City of Biddeford
Planning Board
October 05, 2022 6:00 PM City Hall
Council Chambers, & Zoom
Please click the link below to join the webinar:
<https://biddeford.zoom.us/j/96025494853?pwd=ZlM2SUxVVHRZeVlmUnJZV2ExU1dmZz09>
Passcode: 140225
Or One tap mobile :
US: +13126266799,,96025494853# or +16465588656,,96025494853#
Or Telephone:
Dial(for higher quality, dial a number based on your current location):
US: +1 312 626 6799 or +1 646 558 8656 or +1 646 931 3860 or +1 301 715 8592 or +1
309 205 3325 or +1 719 359 4580 or +1 253 215 8782 or +1 346 248 7799 or +1 386 347 5053
or +1 564 217 2000 or +1 669 444 9171 or +1 669 900 9128
Webinar ID: 960 2549 4853
International numbers available: [https://biddeford.zoom.us/u/acEKRSY1Di](https://biddeford.zoom.us/j/96025494853?pwd=ZlM2SUxVVHRZeVlmUnJZV2ExU1dmZz09)

STATUS: Planning Board Meeting-City Council Chambers October 5, 2022, 6:00PM

Re: 2022.37 Sketch Plan Review for a proposed 13 Unit Multifamily residential building at 69 Elm St.

Re: 2022.38 Sketch Plan Review for a proposed single family home and 8-unit duplex subdivision at 37 Newtown Rd.

SUBDIVISION PLAN
OF:
NEWTOWN ROAD SUBDIVISION
37 NEWTOWN ROAD
BIDDEFORD, MAINE
FOR:
COASTAL OAKS, LLC
198 SACO AVENUE

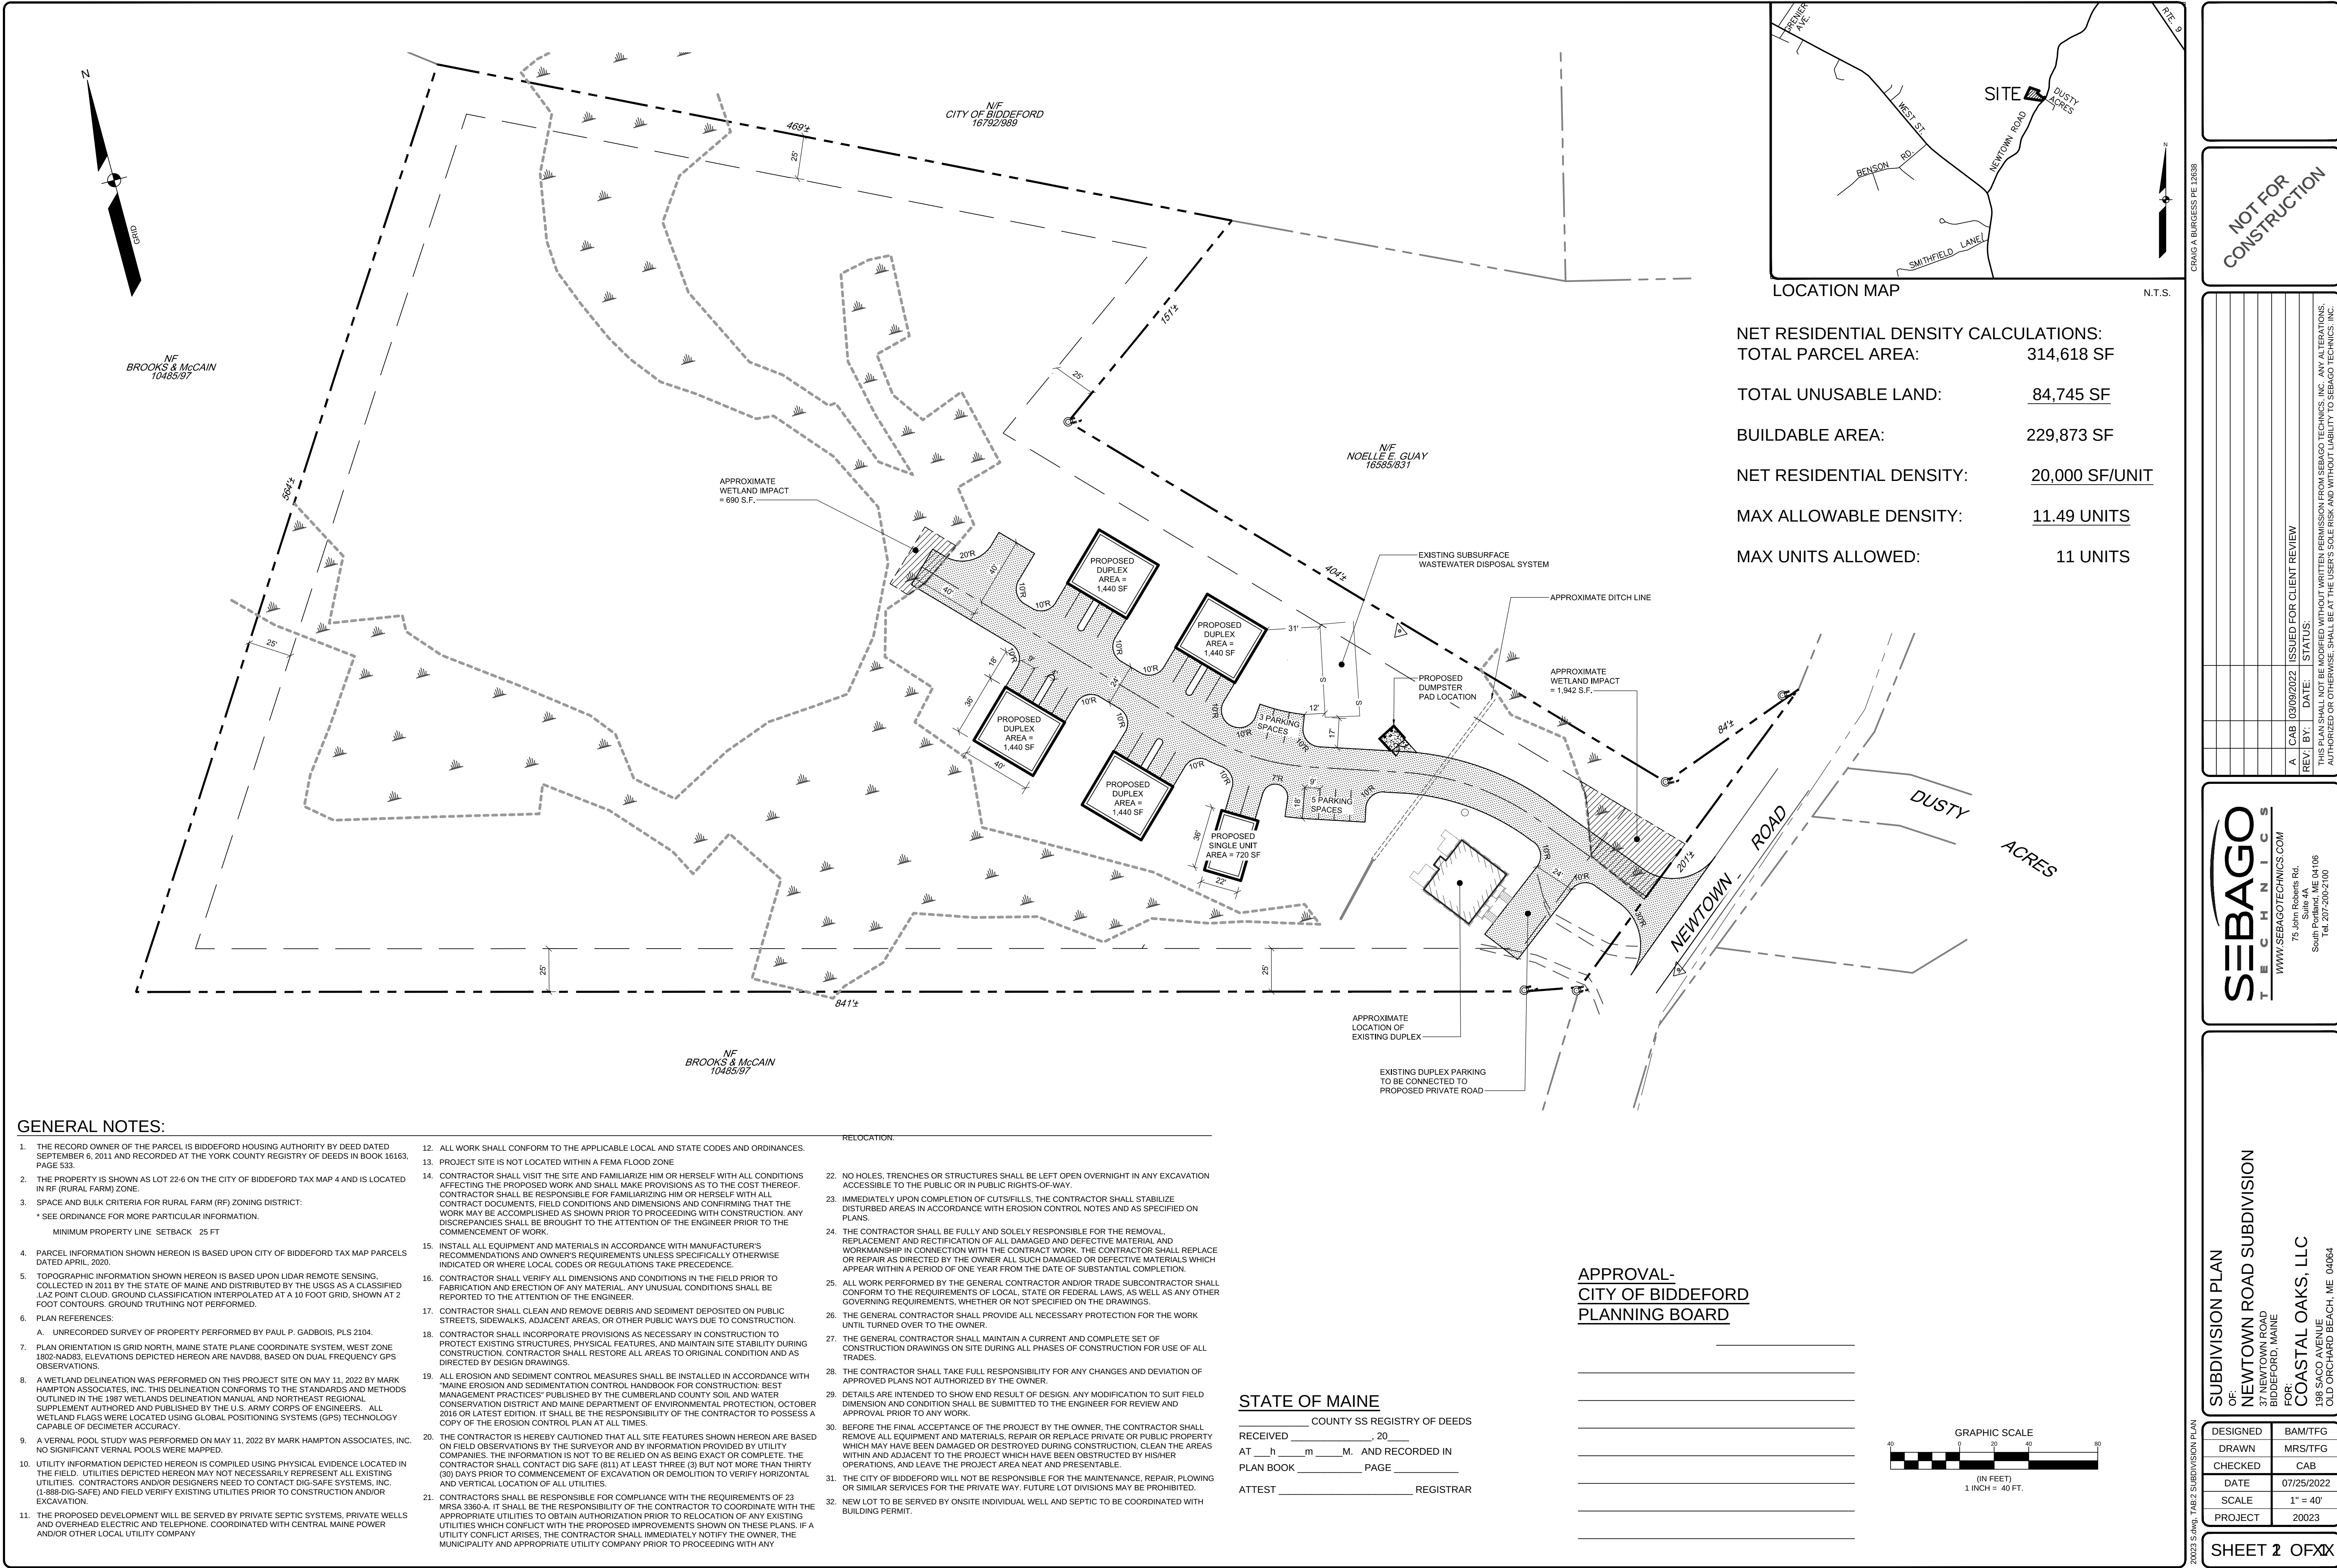
- Note 31 is the standard private way note from the code. Is a private way proposed or necessary?
- The application states that electric and communication will be underground, while note 11 suggests an above ground installation for these utilities.
- The purpose of note 32 is unclear.
- The application form has the box checked indicating it is a subdivision application. For a development of this nature, site plan and subdivision approvals may be required.
- Should any ADA accessible parking spaces be provided?
